LR-N04-0040

**RESPONSE TO REQUEST FOR ADDITIONAL INFORMATION
REGARDING RELIEF REQUEST S1-RR-I3-B21,
NRC ORDER EA-03-009 ON REACTOR PRESSURE VESSEL HEAD INSPECTIONS
SALEM GENERATING STATION UNIT NO. 1
FACILITY OPERATING LICENSE NO. DPR-70
DOCKET NO. 50-272**

**SALEM GENERATING STATION
UNIT NO. 1
FACILITY OPERATING LICENSE NO. DPR-70
DOCKET NO. 50-272
REQUEST FOR ADDITIONAL INFORMATION
RELIEF REQUEST S1-RR-I3-B21
NRC ORDER EA-03-009**

Figure 3-1
Trinity Probe – Lower TOFD Transducer at Top of Chamfer

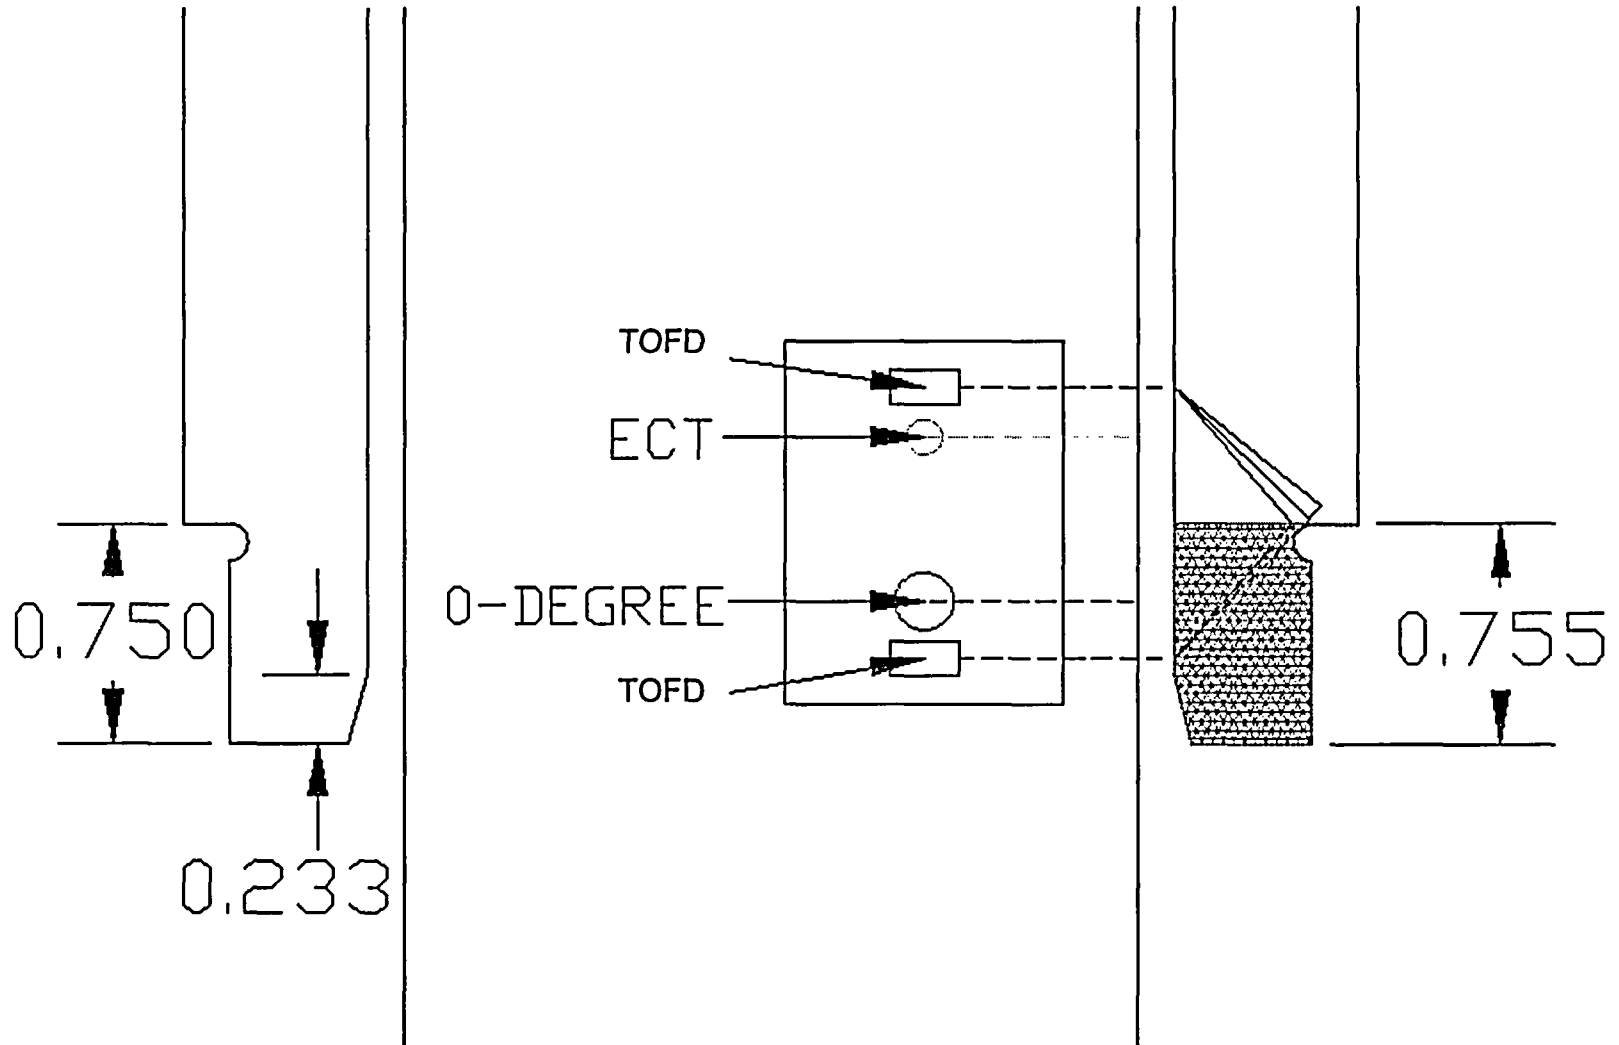
Provide cross section drawings showing limitations of the UT examinations (nozzle design and test equipment). What is the expected examination volume for the different nozzle angles and designs?

The penetration nozzles installed in the Salem Unit 1 Reactor Vessel head have a 15 degree chamfer that is 0.233 inches deep on the inside diameter (ID) of the tube. There is also a threaded area with a thread relief on the outer diameter of the tube that extends up 0.75 inches from the bottom. These geometries limit the coverage for both of the UT inspection tools that will be used at Salem. When the lower transducer on the probes goes below the top of the ID chamfer, the probes lose contact with the ID surface and it is not possible to obtain data.

Westinghouse will use two probes to perform UT inspection of the penetration nozzles at Salem. The trinity probe will be used to inspect nozzles that contain thermal sleeves (53) and part-length CRDM drive shafts (7 total). The open housing probe will be used to inspect nozzles without thermal sleeves (19 total). Both probes use circumferential time of flight tip diffraction (TOFD) as the primary crack detection method. The TOFD technique uses two transducers (one a transmitter, and one a receiver). For detection of circumferential cracks, the transducers are oriented along the vertical axis of the probe. The focus point of the TOFD beam is at the midpoint between the upper and lower transducers. Credit is only taken for inspecting areas that are covered by the focus point. The open housing probe has a PCS-24 transducer with a 55 degree angle of refraction. The Trinity Probe has a PCS-23.4 transducer with a 44 degree angle of refraction. The transducer spacing for the Trinity Probe is less than that of the open housing probe and the transducers are also a smaller size. This causes the focus point of the Trinity Probe transducers to be at a lower elevation than the open housing probe focus point when the probes reach the top of the ID chamfer. Therefore, the Trinity Probe would cover more area at the bottom of the tube. However, due to the difference in the refracted angles, the thread relief on the outside diameter (OD) of the tube interferes with the TOFD beam for the Trinity Probe. So there is an additional area above the thread relief where the Trinity Probe cannot inspect. Figure 3-1 shows the lower transducer at the top of the ID chamfer and the TOFD beam interference with the OD thread relief. Figure 3-2 shows the probe at the minimum elevation where the TOFD beam is not interrupted by the thread relief. The hashed areas from both figures make up the total portion of the tube that cannot be inspected. The dimensions listed in the Table 3-1 are based on the maximum coverage limitation of 0.851 inches shown in the Figure 3-2. With the PCS-24 transducer, the open housing probe circumferential TOFD beam is not interrupted by the OD thread relief. In addition to the circumferential TOFD transducer, the open housing probe has an axial TOFD transducer that the Trinity Probe does not have. The axial TOFD signal allows the open housing probe to inspect the tube down to the top of the ID chamfer. The dimensions listed in the Table 3-1 reflect the axial TOFD transducer coverage limitation of 0.233 inches. This is why the open housing probe coverage is consistently greater than the Trinity Probe coverage. Figure 3-3 shows both the axial and circumferential open housing probe TOFD coverage.

Figure 8-1

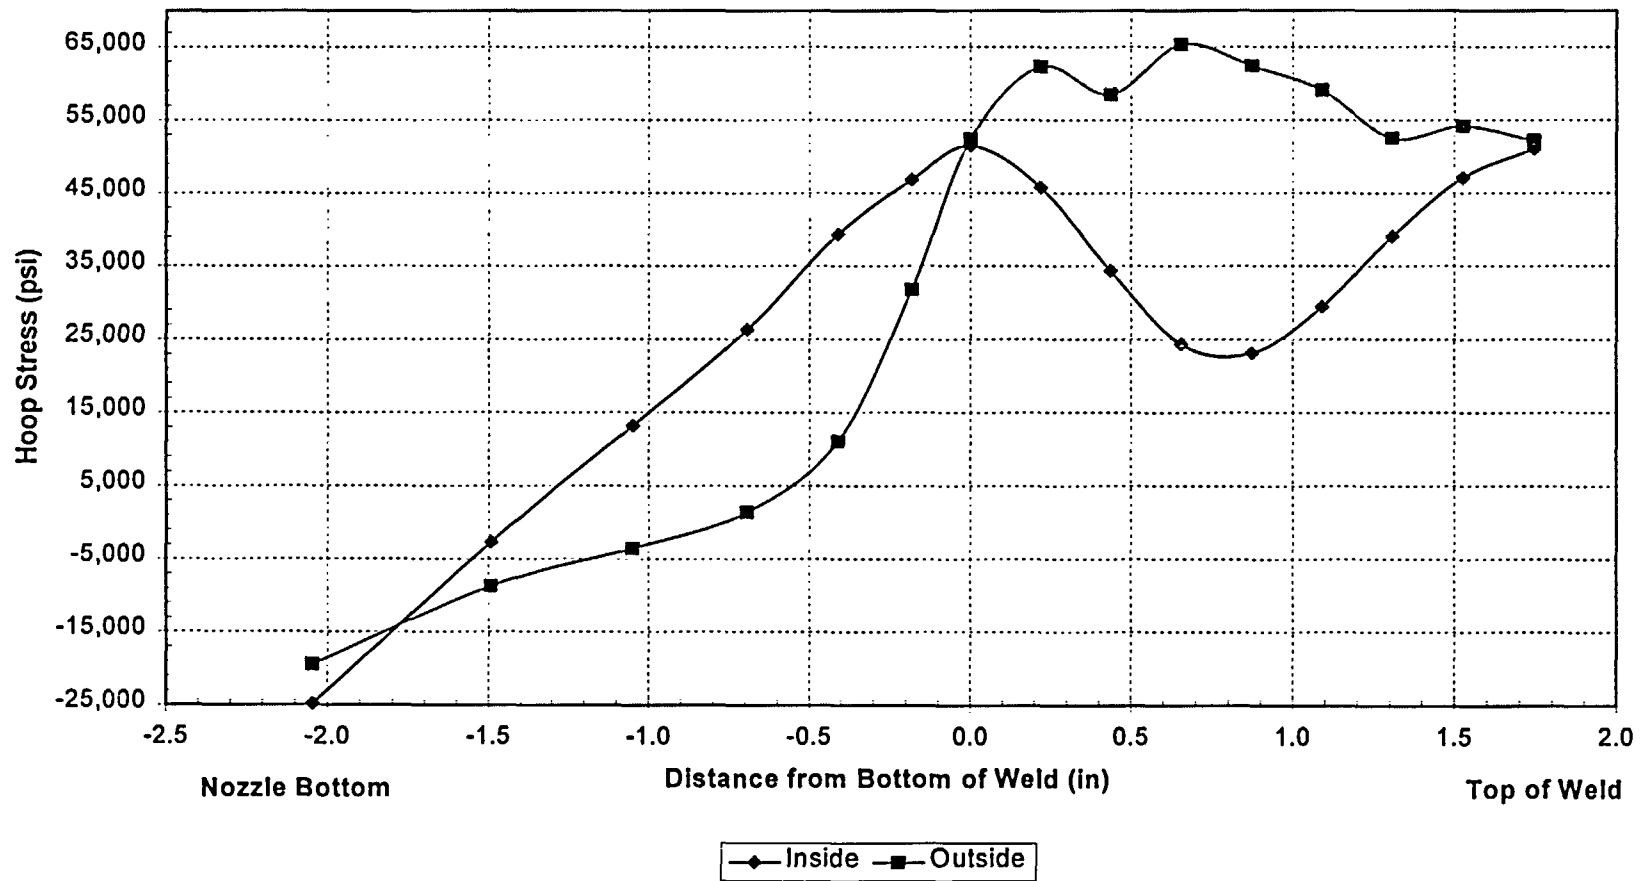
The request states that "UT of the most highly stressed portion of the nozzle (the weld heat affected zone) is unaffected by this limitation." Provide tabular listings or graphs of the maximum stresses in the cross-section from the top of the J-groove weld region to the nozzle end for a range of nozzle angles.

Figures 8-1 through 8-7 are graphs of the inside and outside surface hoop stress distribution from the top of the J-weld to the bottom of the head penetration nozzles. Graphs are provided for the uphill side and the downhill side of the head penetrations for four nozzle angles. There are a total of 15 nozzle angles for the head penetrations at Salem Unit 1. Selected rows of penetrations and the center penetration were analyzed to provide additional results so that a trend can be established as a function of radial location. The penetration nozzle angles selected for this analysis consist of the center penetration (0-degrees), the outermost penetration (48.7°) and two angles in between the center and the outermost penetrations (26.2° and 44.3°).

Figure 9-1
Through-Wall Axial Crack Growth with Initial Upper Crack Tip located at 0.5 inch Below the Weld (Center CRDM Penetration)

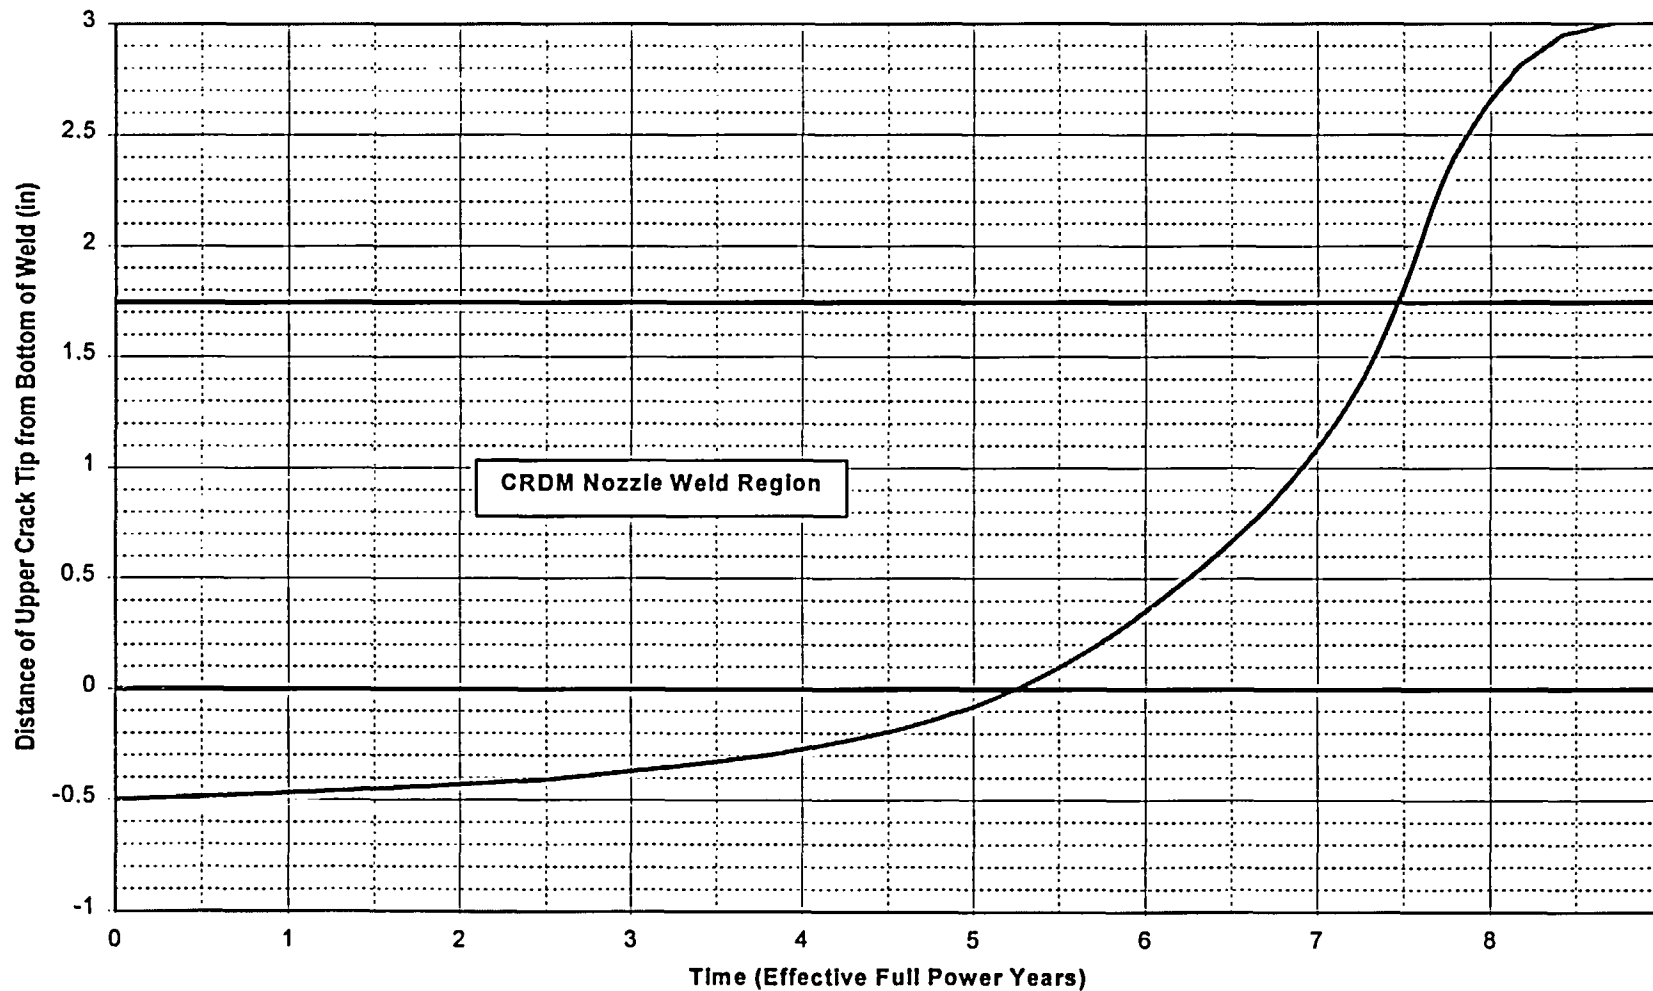
Provide a technical justification, such as an analysis or an evaluation, to show that cracks initiated from the unexamined area will not propagate into the pressure boundary and exceed the ASME Code allowable crack sizes within a minimum of one operating cycle using a conservative crack-growth rate from industry experience. Describe uncertainties in this calculation (e.g., stress levels, crack-growth rate, etc.) and the uncertainty in the results.

A crack growth calculation below the calculated distance below the tip of the weld was performed demonstrating that more than one operating cycle would elapse before a postulated flaw in the unexamined area of the penetration nozzle would propagate into the pressure boundary formed by the J-groove weld. An operating cycle for Salem Unit 1 is 1.5 calendar years, and is typically less than 1.5 Effective Full Power Year (EFPY). The methodology and the technical basis of the crack growth calculation, which was based on the hoop stress distribution provided in the response to Question 8 and the Primary Water Stress Corrosion Cracking (PWSCC) crack growth rate recommended in MRP-55 Rev.1, are provided in WCAP-16214-P, Structural Integrity Evaluation of Reactor Vessel Upper Head Penetrations to Support Continued Operation: Salem Units 1 and 2.

The distance below the J-groove weld to the top of the zone that cannot be inspected has been calculated to be more than 1 inch based on design dimensions (see Table 3-1) with the downhill side of the penetration nozzle being more limiting. However, the upper extremity of an axial through-wall flaw was conservatively postulated to be located at 0.5 inches or less below the J-groove weld in the crack propagation calculation for the downhill side of the penetration nozzle. Figures 9-1 through 9-4 provide results of the calculation. The calculation demonstrates that the minimum time for a flaw to propagate from that location to the bottom of the J-groove weld would be at least 3 EFPY, which is more than 2 operating cycles.
